UNITED STATES PATENT AND TRADEMARK OFFICE

10/731,340

<p align="center">Office Action Summary</p>	<p>Application No.</p> <p align="center">10/731,340</p>	<p>Applicant(s)</p> <p align="center">ANDERSON, PETER C.</p>	
	<p>Examiner</p> <p align="center">James O. Hansen</p>	<p>Art Unit</p> <p align="center">3637</p>

DETAILED ACTION

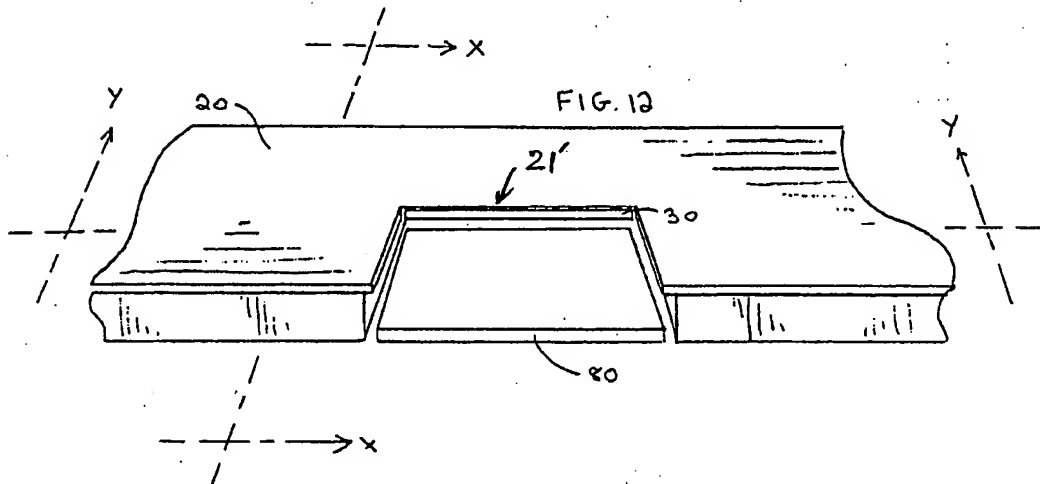
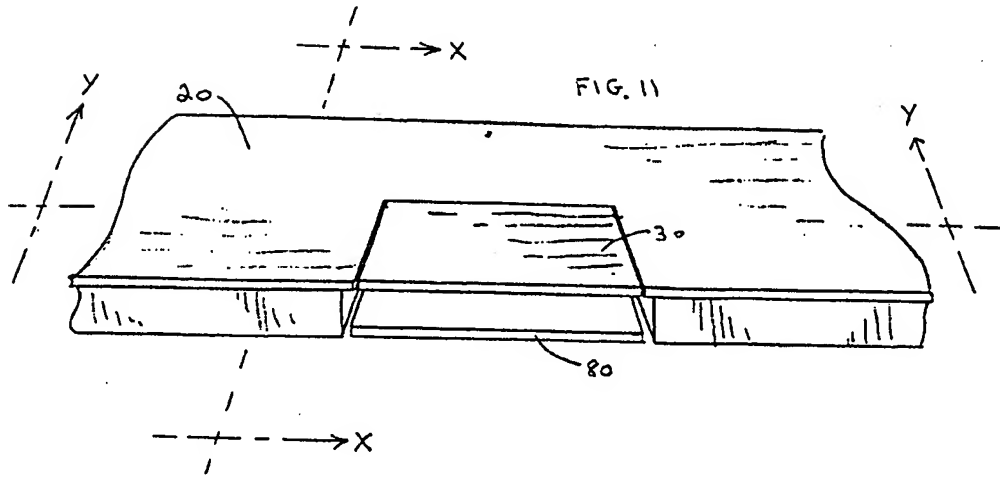
5. The proposed replacement sheet of drawings was received on November 27, 2007. These drawings have not been approved by the examiner since the element labeled "21'" in the drawings is described in the specification as element "20' ". As such, the examiner cannot approve the drawings at this time in the prosecution of the application. Appropriate correction is required.

Not Approved for examination purposes
4/19/07 Jph
